ADDENDUM NO. 1

SEPTEMBER 17, 2024

- A. Project Name: BALL STATE HONORS HOUSE ADDITION
- B. Owner: Ball State University
- C. Owner Project Number: 2024-009.01 BA
- D. Architect: arcDESIGN
- E. Architect Project Number: 24118

E101

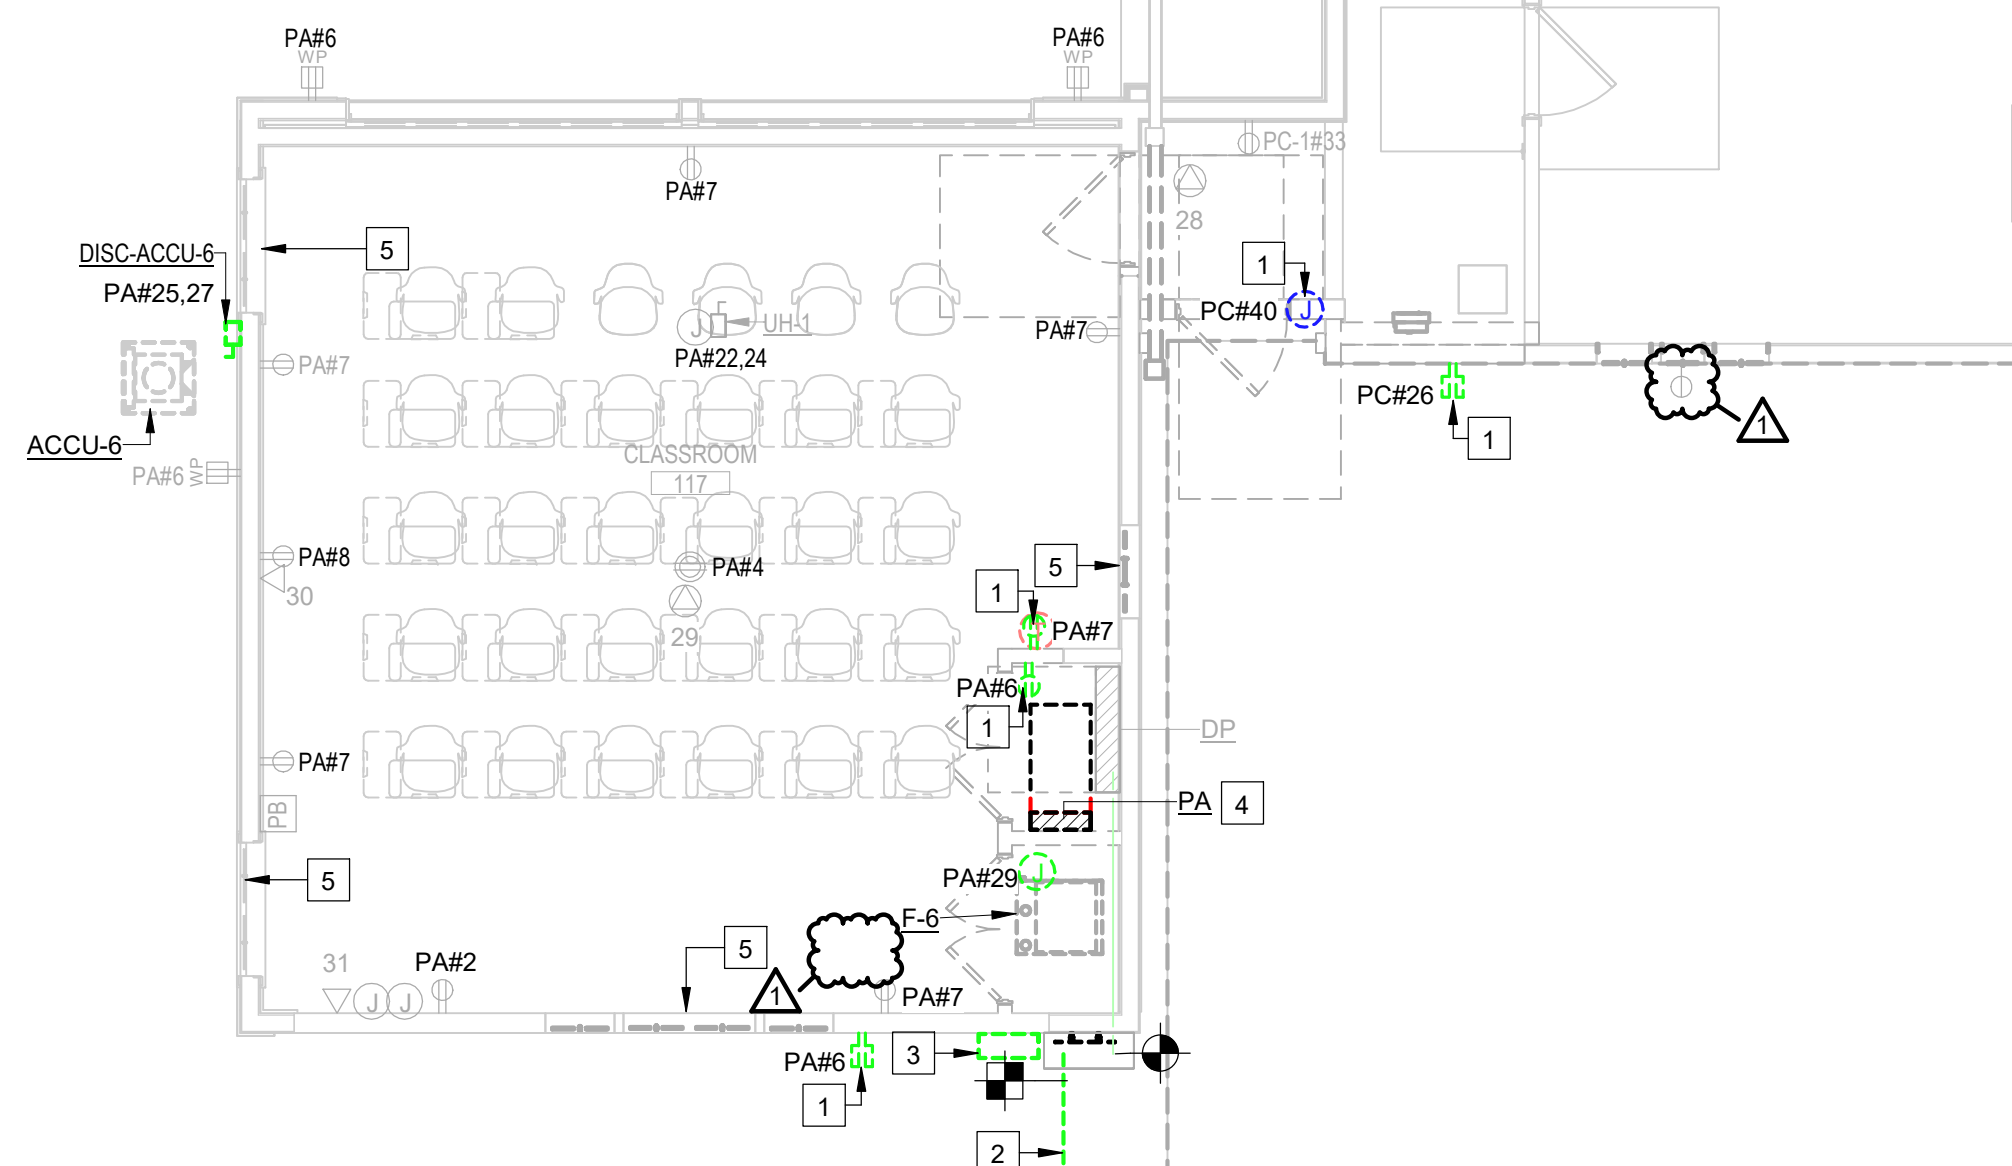
- C. Sheet E101 - FIRST FLOOR ELECTRICAL DEMOLITION LIGHTING PLAN
 - 1. Revise Demolition Note 1 as indicated in the attached revised Sheet.
 - 2. Revise notes on Alternate #1 as indicated in the attached revised Sheet.

- 3. Revise notes on First Floor Demolition Lighting Plan as indicated in the attached revised Sheet.
 - D. Sheet E102 - FIRST FLOOR ELECTRICAL DEMOLITION POWER PLAN

- 1. REMOVE HISTORICAL DECORATIVE EXTERIOR SCONCE LIGHT, TOTAL OF 6 TO BE REMOVED. 5 OF 6 FIXTURES TO BE SALVAGED FOR REUSE. 1 FIXTURE TO BE RETURNED TO OWNER FOR FUTURE USE. REPAIR EXTERIOR WALL AFTER REMOVAL. REMOVE 28 BASE BULB.
- 2. MAINTAIN HISTORICAL DECORATIVE EXTERIOR SCONCE LIGHT.
- 3. REMOVE LIGHT FIXTURES, CONTROLS AND ASSOCIATED WIRING IN THIS ROOM. MAINTAIN RACEWAY FOR REUSE.
- 4. MAINTAIN LIGHTS IN HALLWAY THAT ARE SEPARATED BY BULKHEAD, DOORS, ETC.

- a. PROVIDE NEW LIGHTS IN EXISTING OFFICES TO MATCH LIGHTS IN NEW OFFICES.

E300

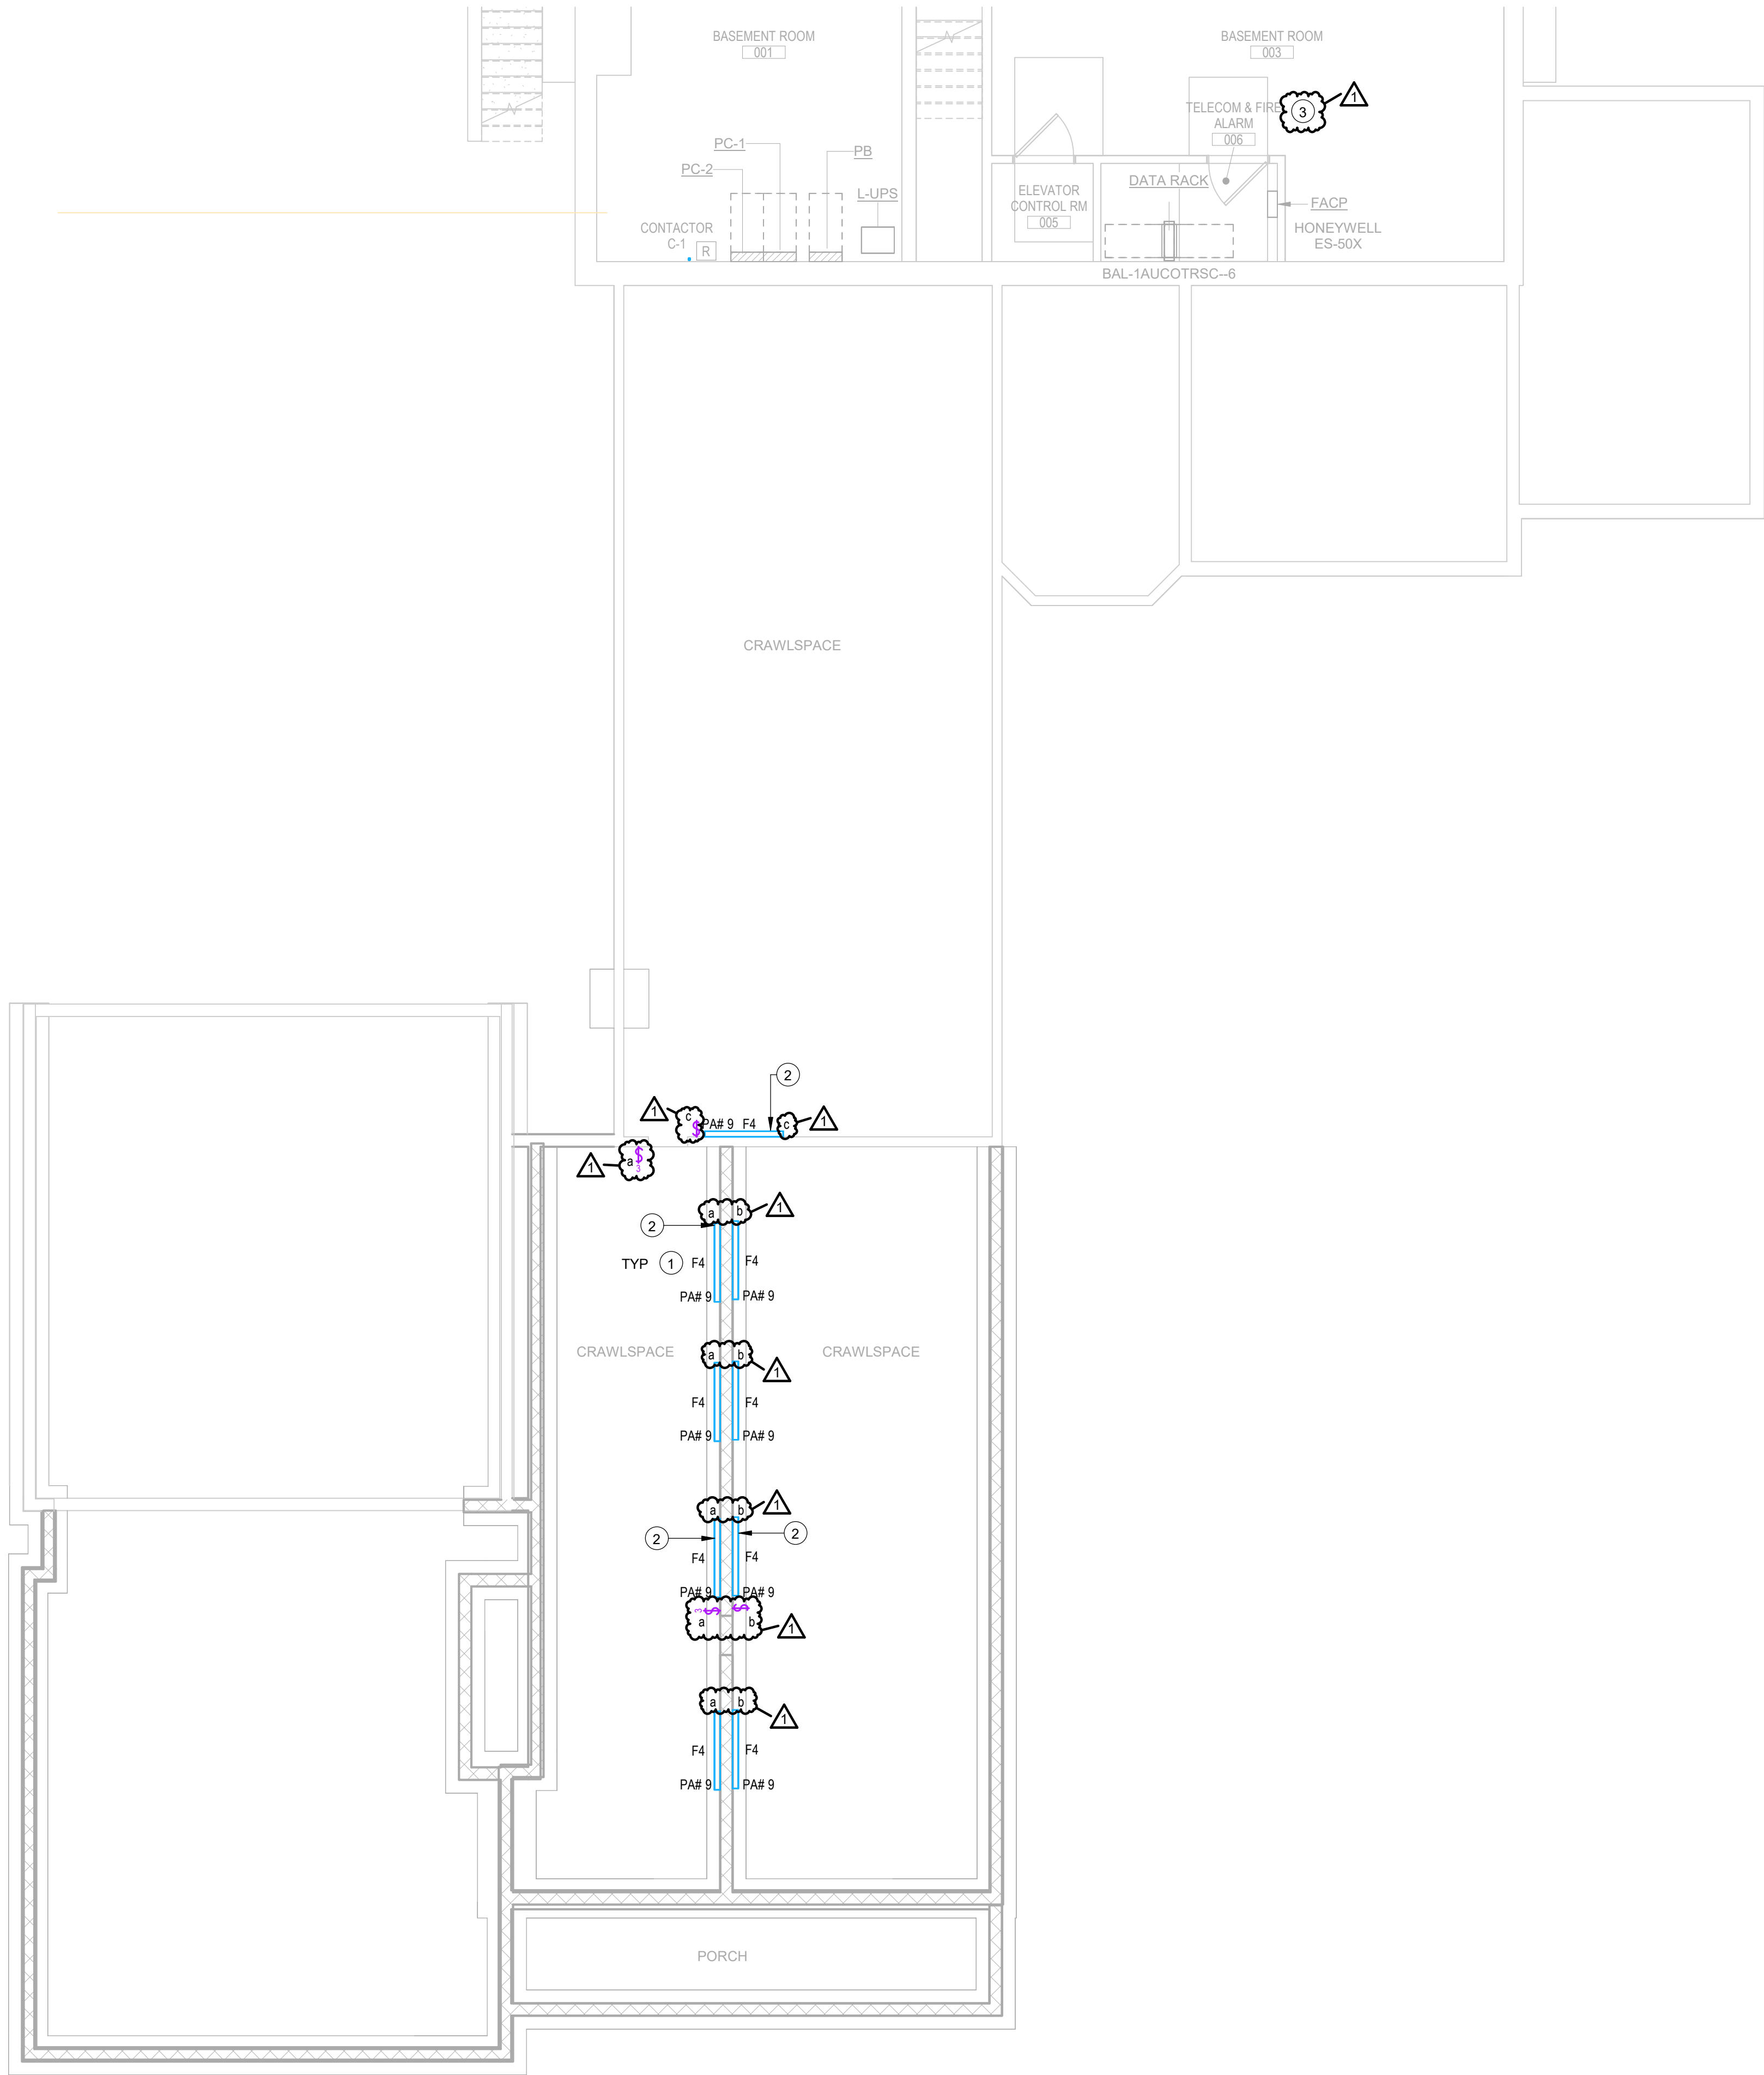
- 1. Add General Note C as indicated in the attached revised Sheet.
 - F. Sheet E300 - BASEMENT & CRAWLSPACE PLAN
 - 1. Add New Plan Note 3 as indicated in the attached revised Sheet.

- 2. Revise notes on Basement Electrical New Plan as indicated in the attached revised Sheet.
 - G. Sheet E301 - FIRST FLOOR ELECTRICAL LIGHTING PLAN
 - 1. Revise Plan Note 1 as indicated in the attached revised Sheet.

1. PROVIDE NEW STRIP LIGHTS IN CRAWLSPACE.
2. PROVIDE ADDITIONAL CONNECTION TO LIGHT FIXTURE FROM L-UPS IN BASEMENT. REFER TO SHEET E100 OR E300 FOR LOCATION. PROVIDE GENERATOR TRANSFER DEVICE (L-UPS RATED).
3. ROUGH-INS FOR TELECOM AND SYSTEMS TO BE ROUTED TO THIS ROOM.
